RESPONSE TO IDEM RWP RESPONSE TO COMMENTS & ADDENDUM I REVIEW

MICHIGAN PLAZA
3801-3823 WEST MICHIGAN STREET
INDIANAPOLIS, INDIANA

IDEM INCIDENT NUMBER: 0000198

JANUARY 16, 2009

**PROPOSED CAP18 INJECTION REMEDIATION
(Round 2 - February 2009)**

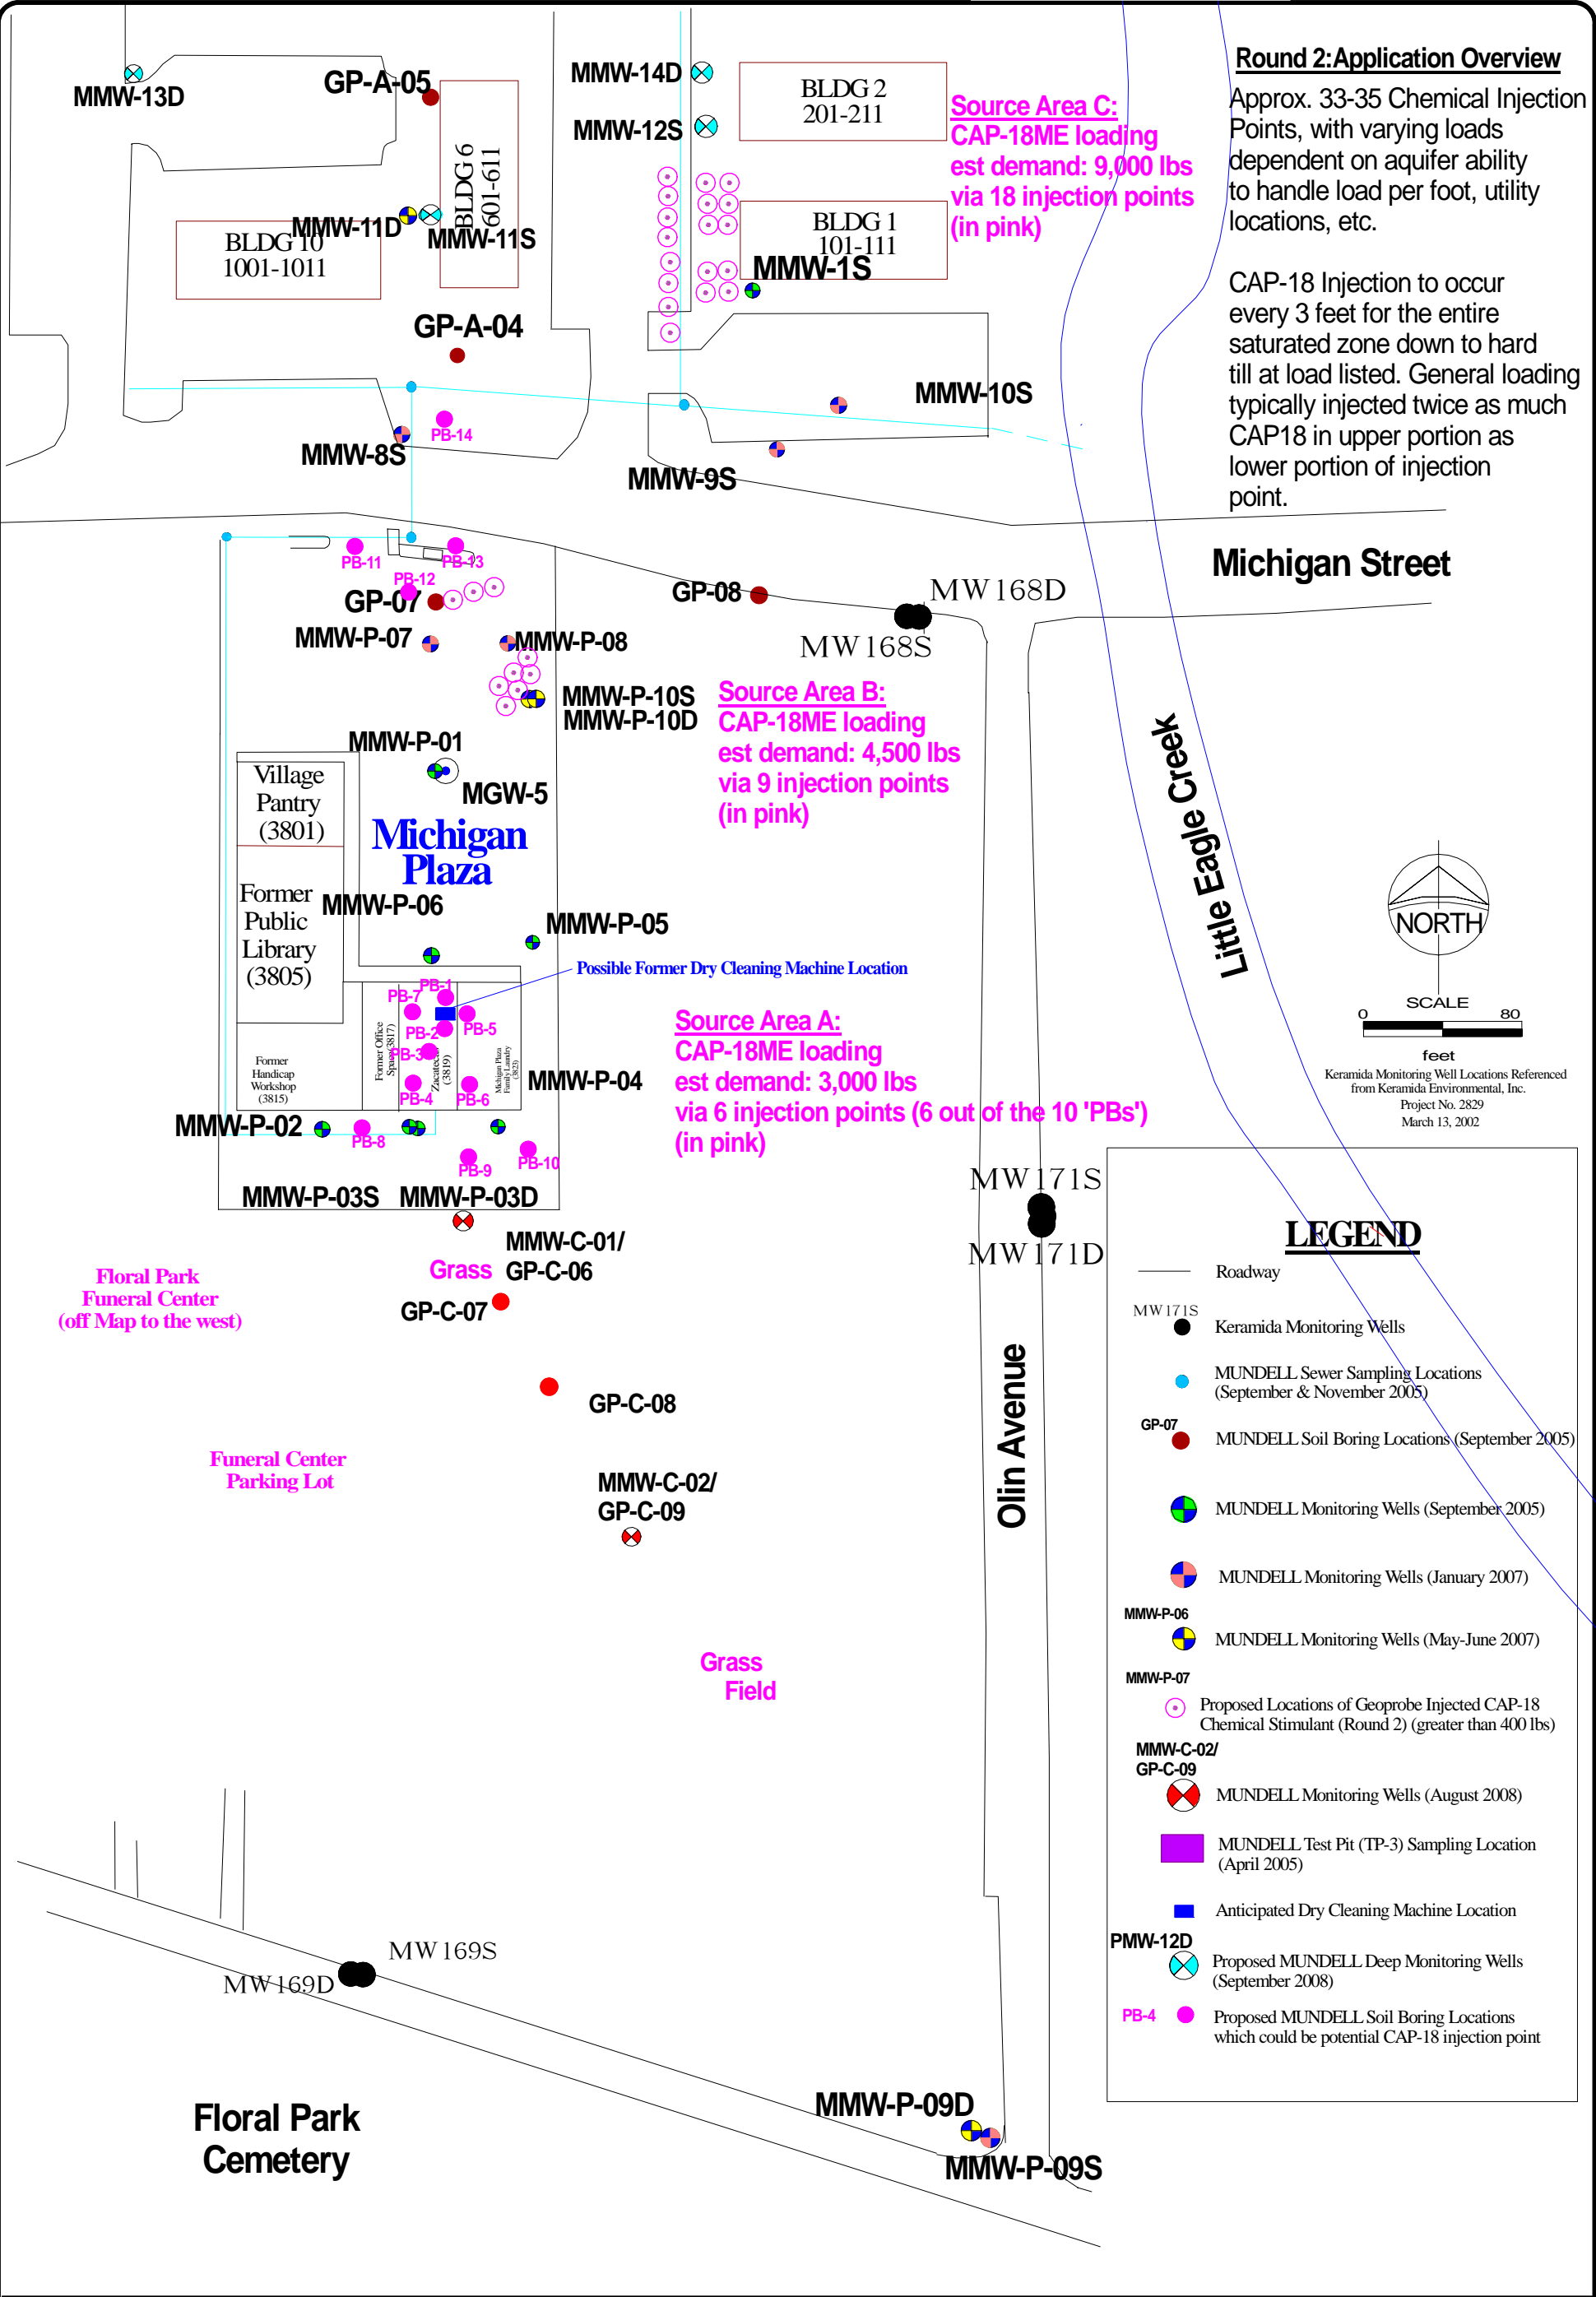
IDEM Comment No.4. Four quarters of data have been submitted since the initial CAP 18 injections. As the contaminants biodegrade to DCE and vinyl chloride, they also become less amenable to reductive processes. Vinyl chloride, in particular, is often best remediated by oxidation. Since most of the plume has already degraded to less chlorinated VOCs, the consultant may wish to investigate manipulating the redox potential of the groundwater. Much additional information on bioremediation of chlorinated solvents is available from the Interstate Technology and Regulatory Commission (ITRC) at www.itrcweb.org.

Please find attached (**Figure 3**) the proposed CAP-18 ME injection (Round 2) locations. MUNDELL will proceed with the additional soil and groundwater sampling beneath and around the Plaza building, and also in *Source Area B* (as detailed in the *RWP Addendum I, November 6, 2008*) for addressing the soil medium in February 2009. MUNDELL will oversee the advancement of geoprobe borings inside the building with a small LT-50 rig, which would allow drilling/testing inside the building in locations yet uncharacterized, followed by CAP-18 ME injection in select boring locations.
